## Accessibility Survey

## City of Downey Gunderson Avenue - Rosecrans Avenue To Reydon Street

Rosecrans Avenue To Reydon Street  
Downey, CA 90242

Date of Inspection  
12/1/2016

Sidewalks : Missing Sidewalk

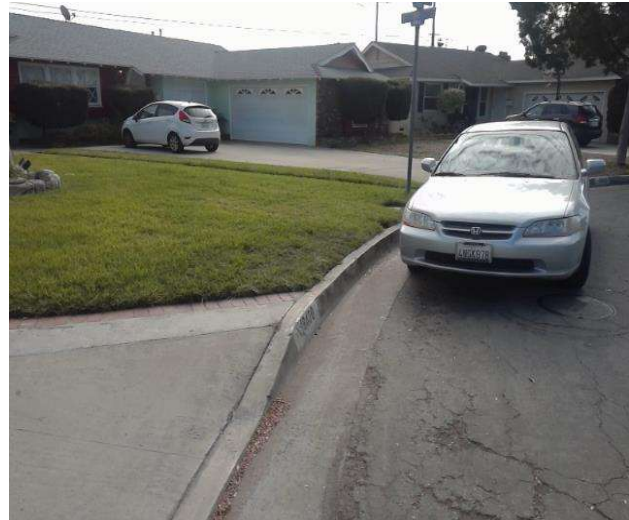
Section of sidewalk is missing and consists of dirt, grass or gravel.

**On-Site Finding** 1158.00 feet

Provide a compliant sidewalk for the missing section.

Sidewalks , Surface : Running Slope

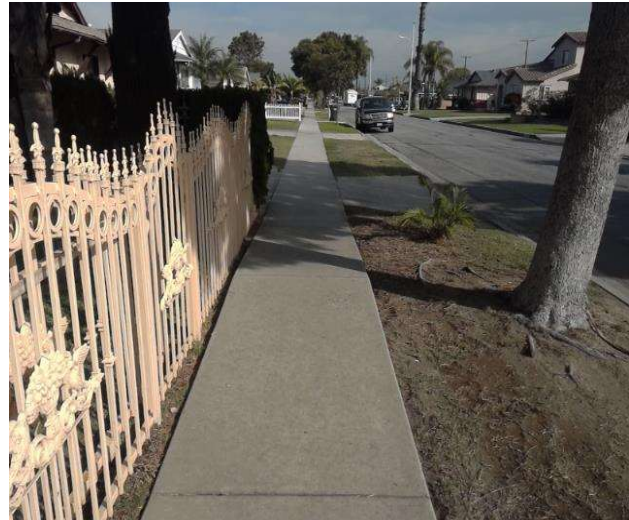
Sidewalk running slope is not compliant.

**On-Site Finding** 5.50 percent for 8.00 feet

Repave the sidewalk surface with the recommended running slope.

Recommendation Up to 5.00 percent
